ULNRC- 04574

**DOCKET NUMBER 50-483  
CALLAWAY PLANT  
UNION ELECTRIC COMPANY  
PROPOSED REVISION TO TECHNICAL SPECIFICATIONS 3.9.4  
"CONTAINMENT PENETRATIONS"; 3.3.6 "CONTAINMENT PURGE  
ISOLATION INSTRUMENTATION" AND 3.3.7 "CREVS ACTUATION  
INSTRUMENTATION"  
TO ALLOW OPEN CONTAINMENT EQUIPMENT HATCH  
DURING REFUELING OPERATIONS**

**ATTACHMENT 2**

**EVALUATION**

ENGINEERED SAFETY FEATURES RESPONSE TIMES

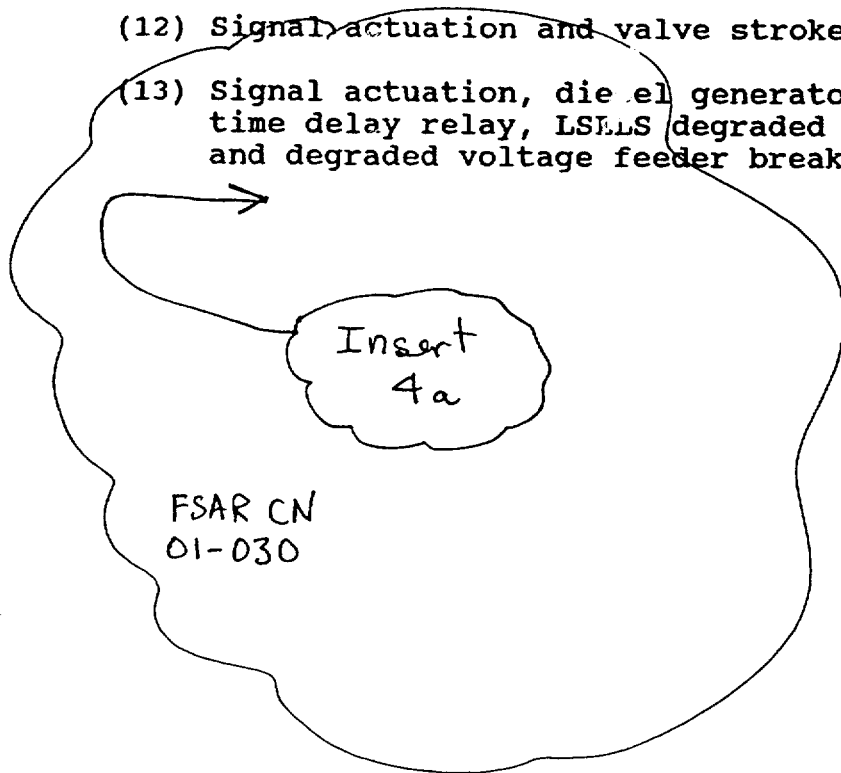
INSERT 4a

(14) The radiation monitor detector is excluded from response time testing. The stated response time accounts for the elapsed time between introduction of a count rate from the detector corresponding to the actuation setpoint and repositioning of the components necessary to achieve Control Room isolation.
